Item Name: Replacement Skidtube (Fits LH or RH)

DRAWING NO. D2650	TITLE 206/407 SKIDTUBE ASSEMBLIES	REV. F	DART AEROSPACE LTD ENGINEERING ORDER		D.E.O. NO. D2650-F-1	SHEET NO. SHEET 1 OF 1	SCALE NTS
DRAWN: <i>[Signature]</i>	CHECKED: <i>A.P.</i>	MFG: APPR. <i>[Signature]</i>	APPROVED <i>[Signature]</i>		DE APPR. <i>[Signature]</i>		
DATE 12.10.12	DATE 12.10.22	DATE 12.10.22	DATE 12.10.22		DATE 12.10.22

CHANGE C'BORED WELDED CROSSBOLT SPACERS TO SWAGED SPACERS

17	18	19	23	D2649	CROSS BOLT SPACER
----	----	----	----	-------	-------------------

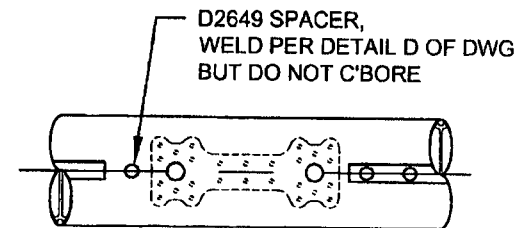
WAS:

ADD DETAIL G BELOW, WHICH IS THE SAME SECTION VIEW AS DETAIL D OF DWG.
C'BORED HOLES ARE **NOW SWAGED** PER DETAIL G BELOW. FOR THE Ø0.375 HOLE THAT IS NOT C'BORED, WELD PER DETAIL D OF DWG (SEE AMENDED DETAIL B FOR REFERENCE).
